MEMORANDUM

Re: **RC-19-001 – RCOZ C Special Exception for a Residence
4586 South Thousand Oaks Drive**

Applicant: **Gary and Nazeli Manukyan**

Zone: **R-1-10 / RCOZ**

SITE PLAN

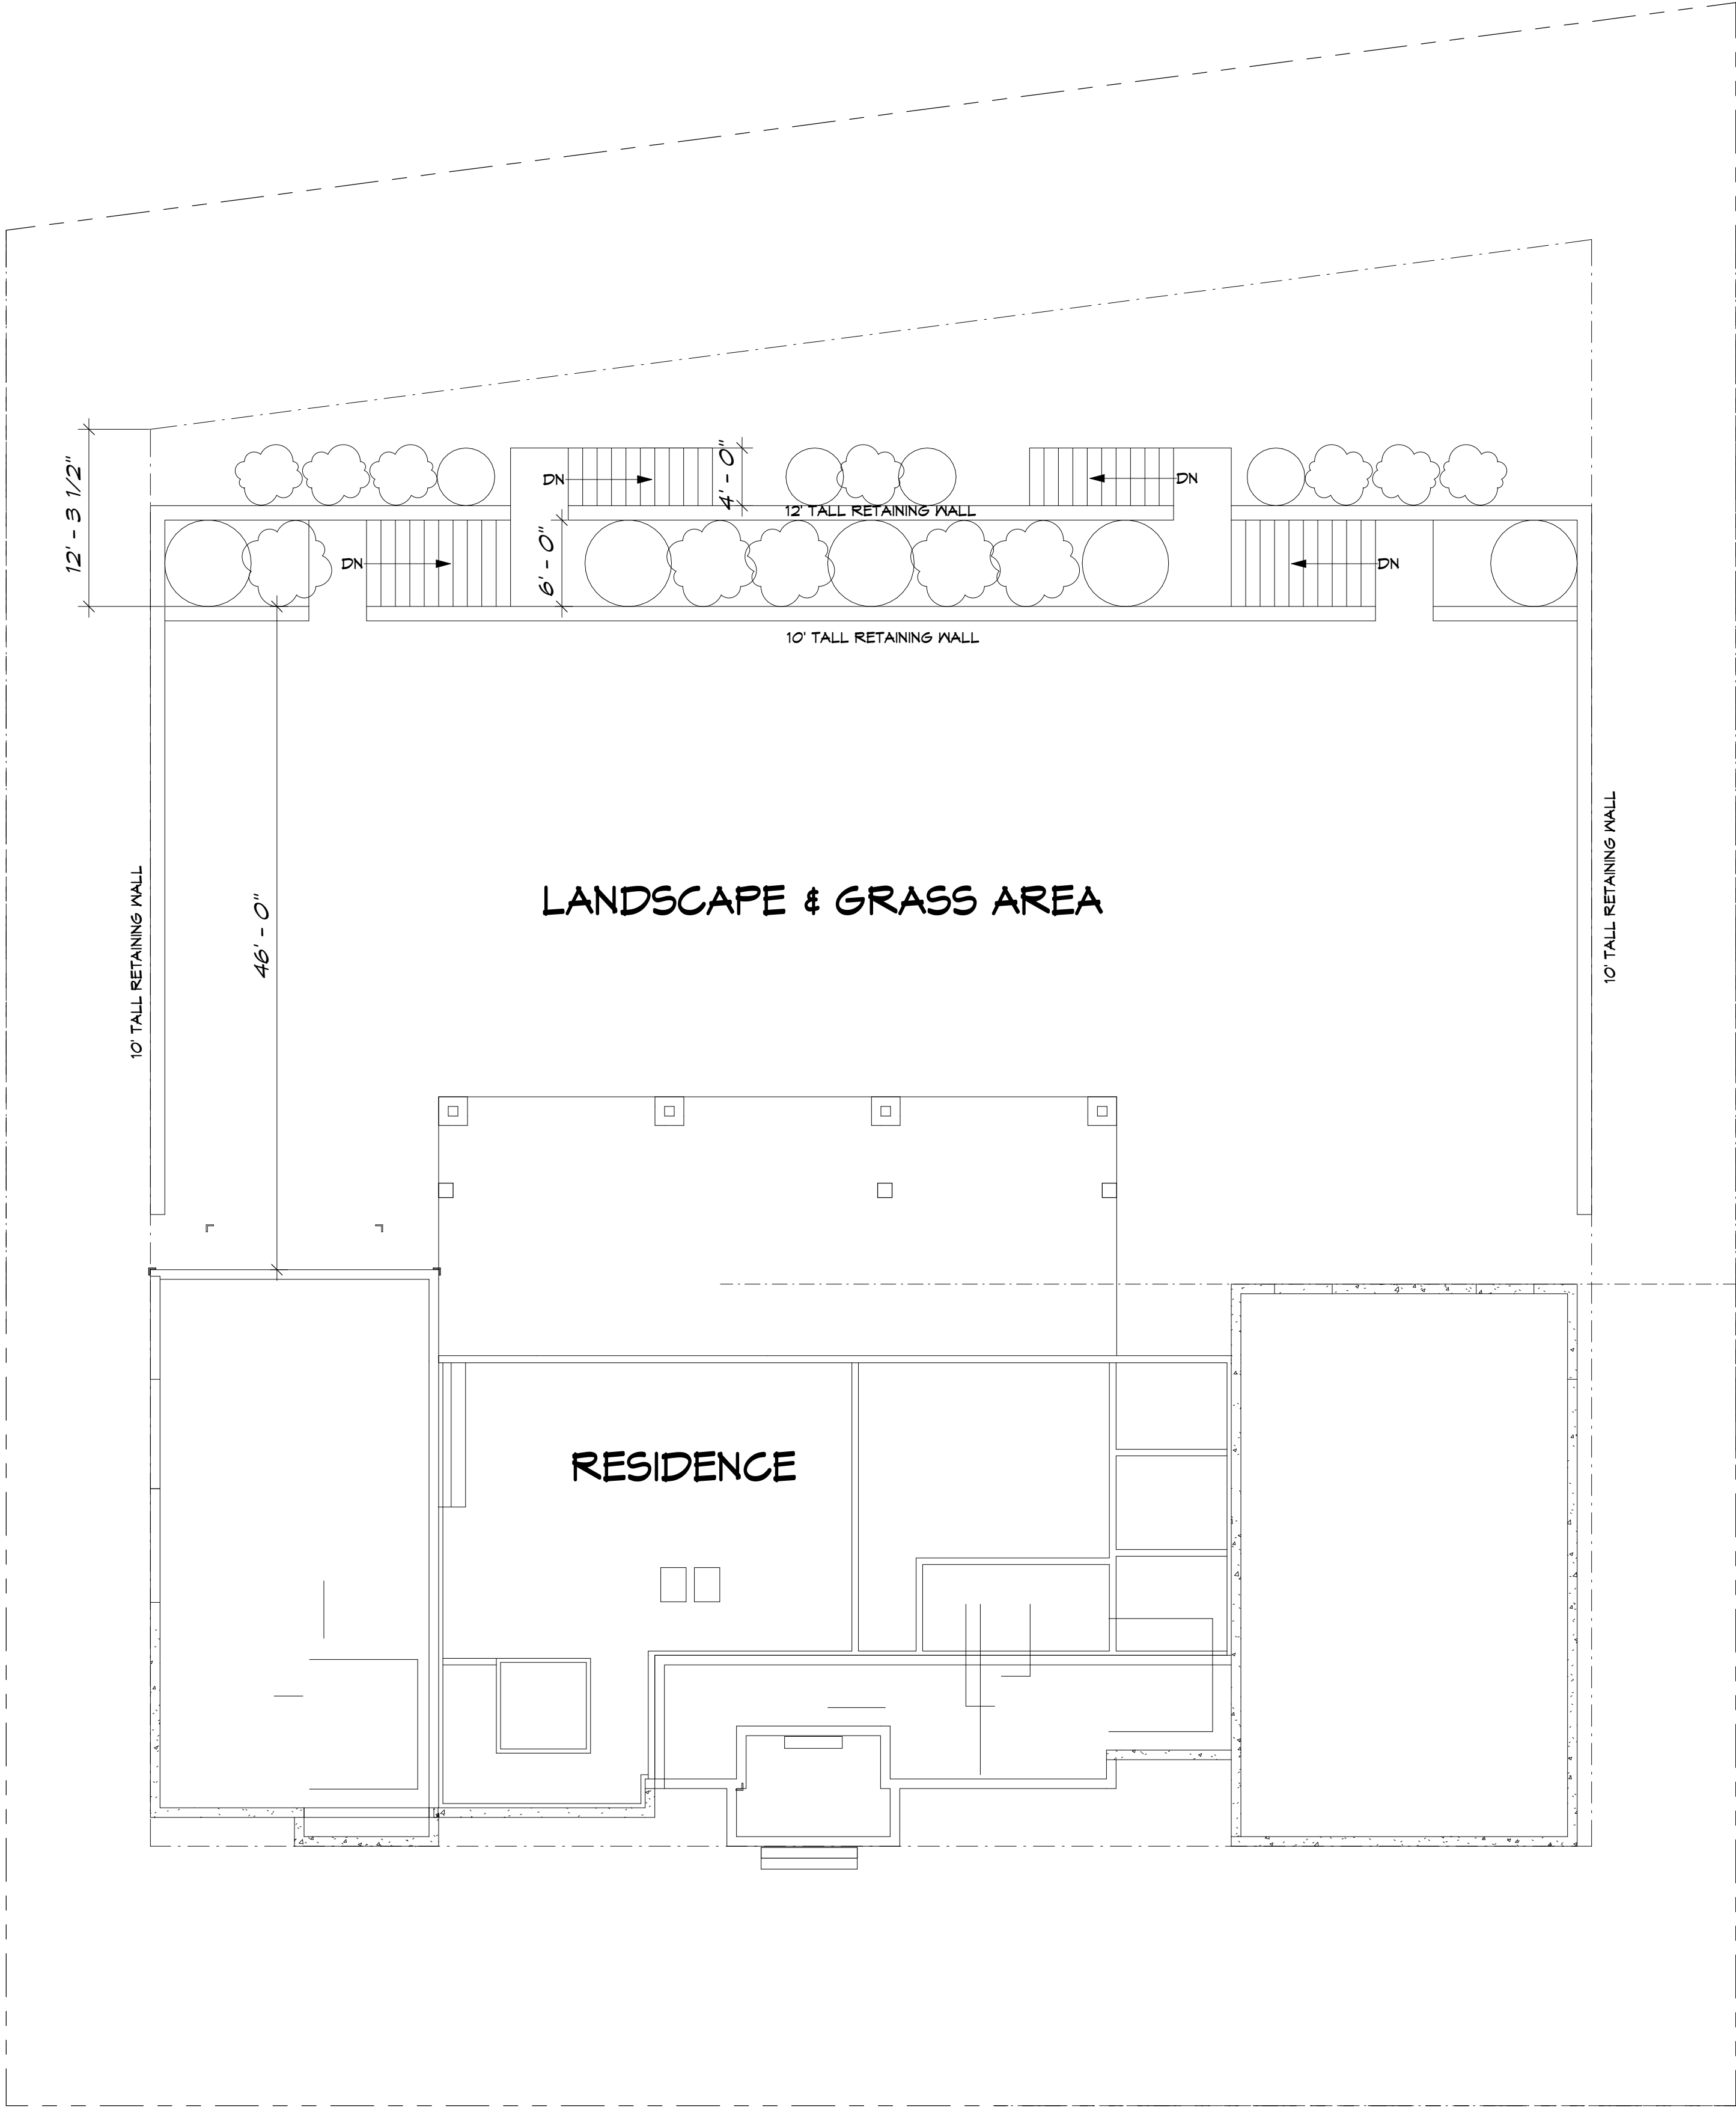
The applicant supplied a site plan that indicates the front yard setback will be 18 feet, as measured from the front property line.

REAR ELEVATION

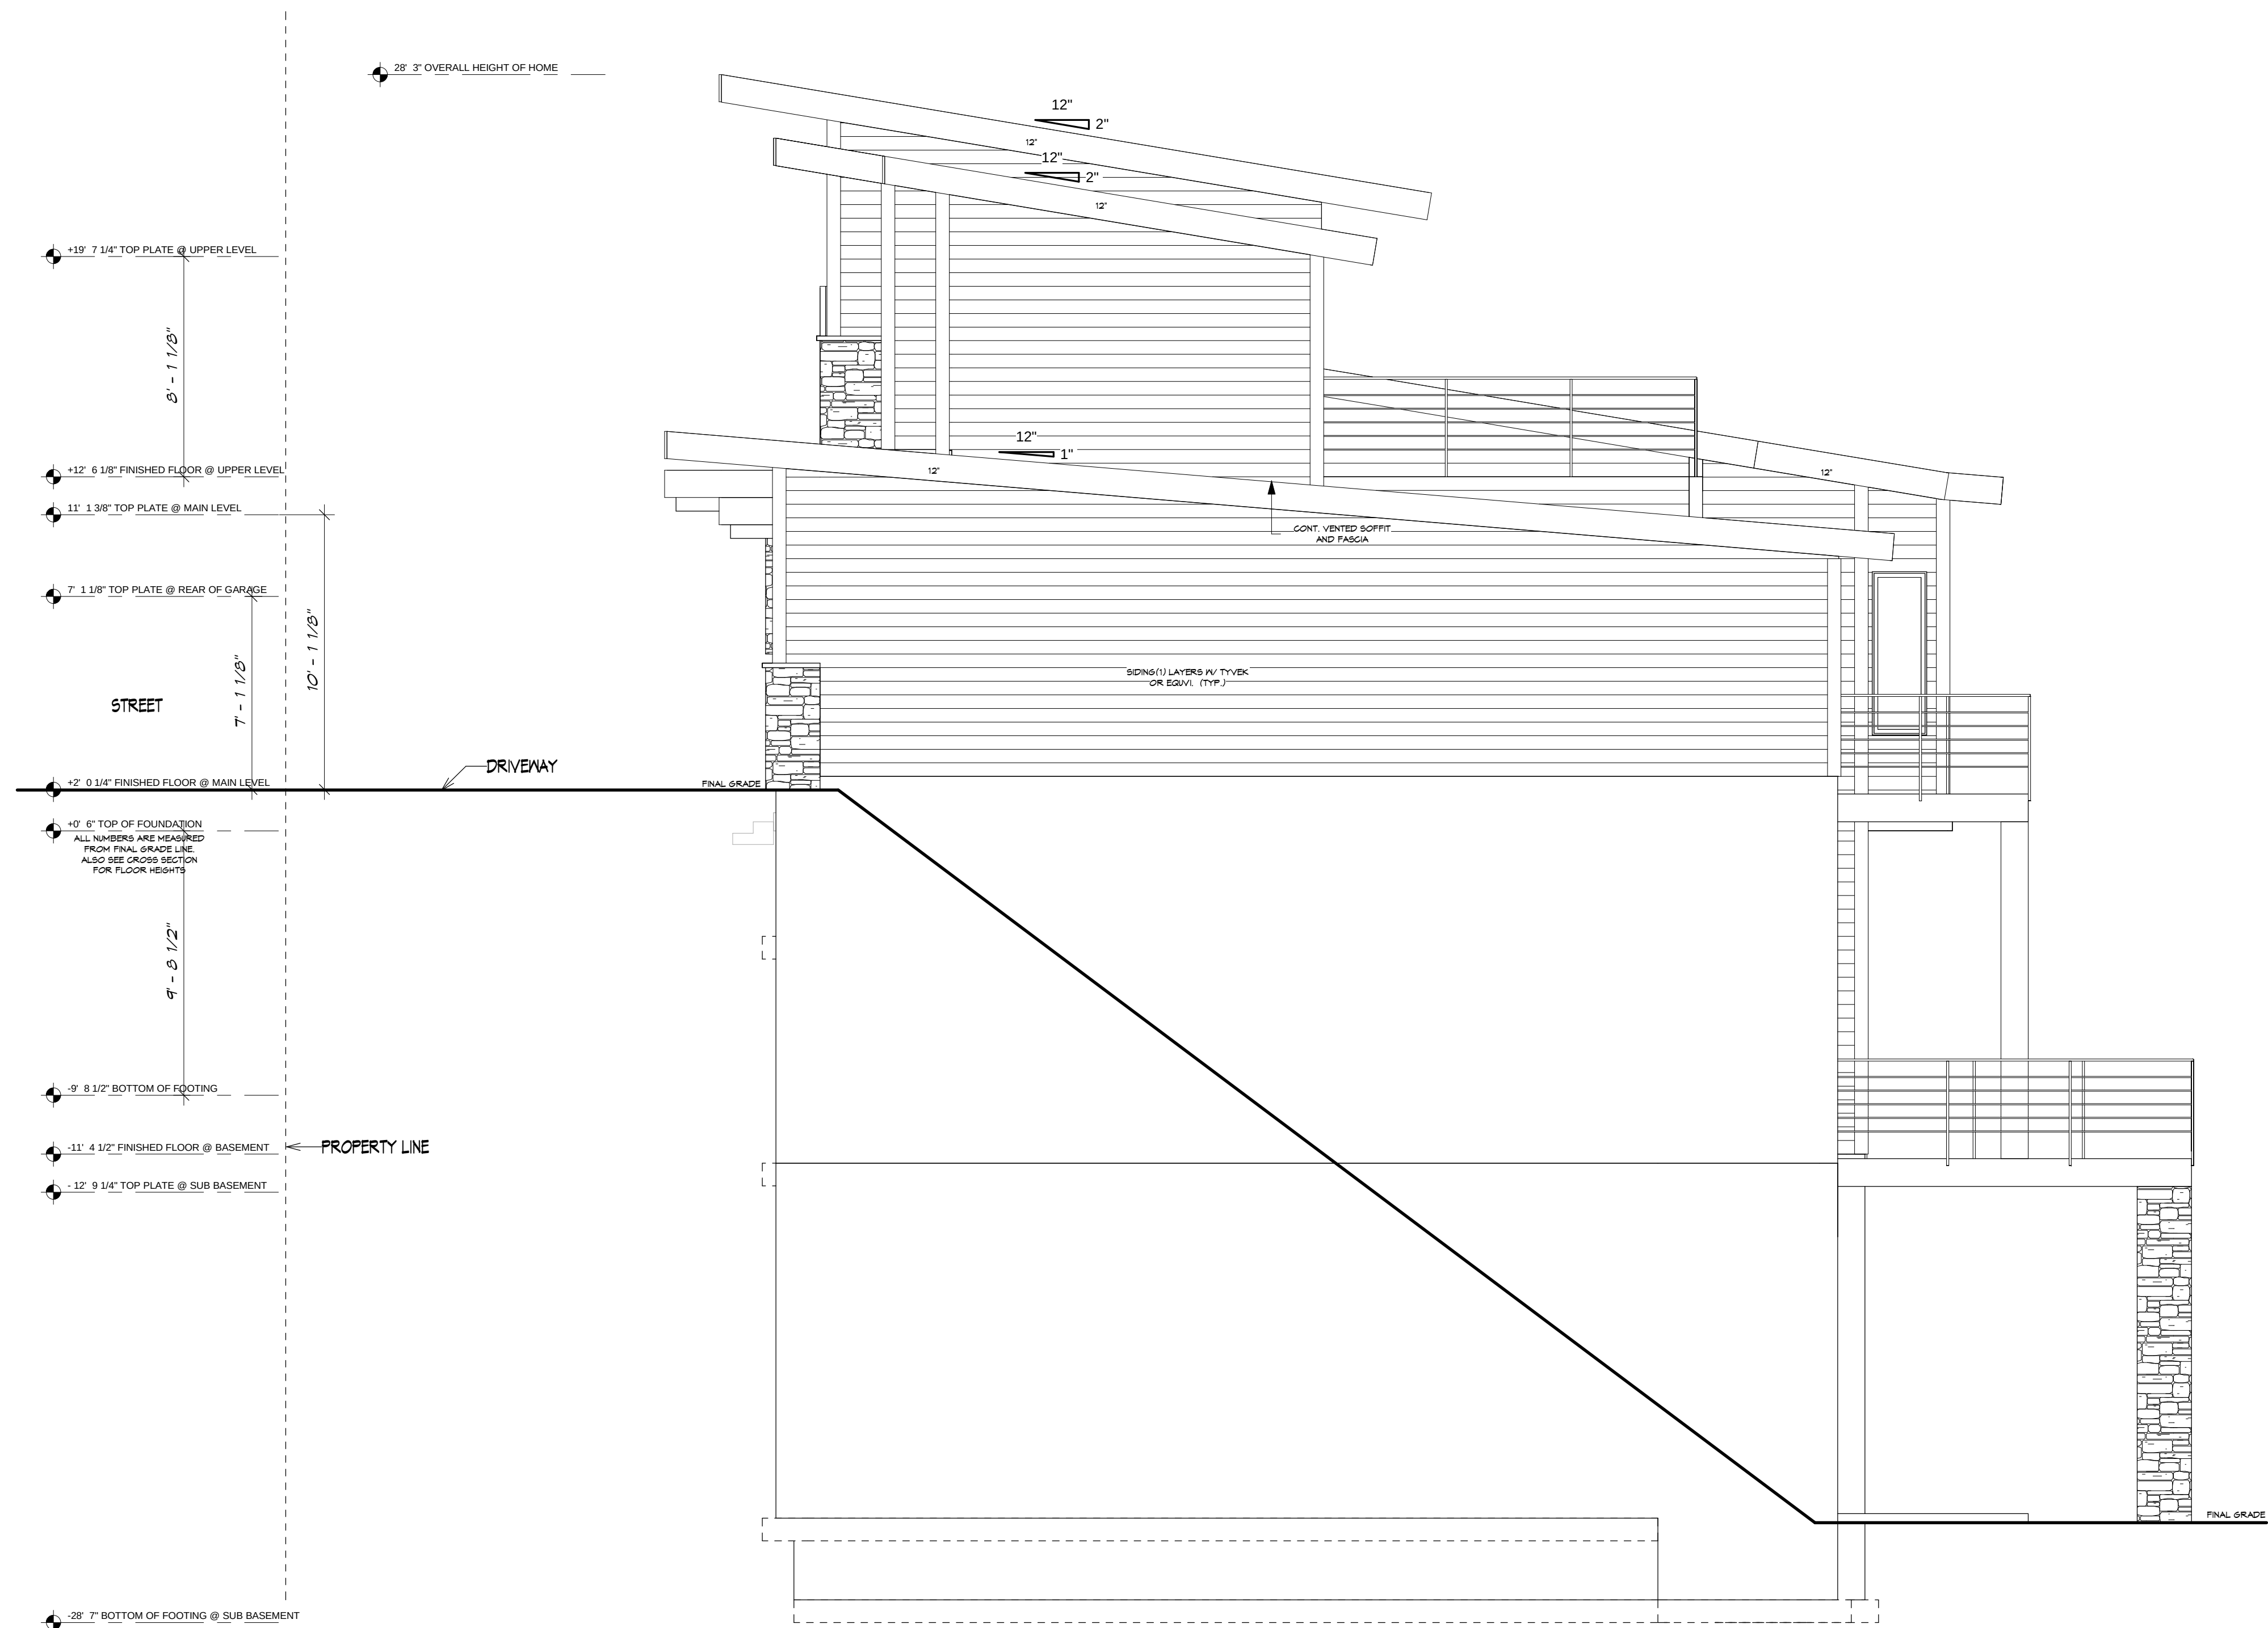
The appearance of the rear of the home, particularly as it impacts residents who live immediately downslope, is a concern to staff. At least three stories of structure would be visible from adjacent properties on Jupiter Drive, with a fourth level set back behind a shed roof. Some of this fourth level exceeds the 30 foot envelope, and this condition this condition may be an adverse effect on downslope property owners. In order to achieve the purpose of RCOZ, staff recommends that the applicant consider additional mitigation to reduce the adverse effects of a significant structure upslope.

Mass. As indicated in Item 2 above, staff has concerns about the mass of the north side elevation, and the rear elevation. Most homes in the subject area, particularly those approved after RCOZ was enacted, have side elevations that provide greater articulation than what the applicant proposes for the north side, and rear elevations that do not exceed three levels.

However, if the applicant meets the burden of proof to justify the exceptions they requested, staff requests that the applicant propose mitigation measures to compensate for the large mass of the home, especially on the north and west elevations. Granting an exception should be conditioned on meeting these mitigation measures. Staff also recommends conditioning the exception on full compliance with the City's Geological Hazards Ordinance, which applies to any area with slopes in excess of 30 percent (19.75.030).
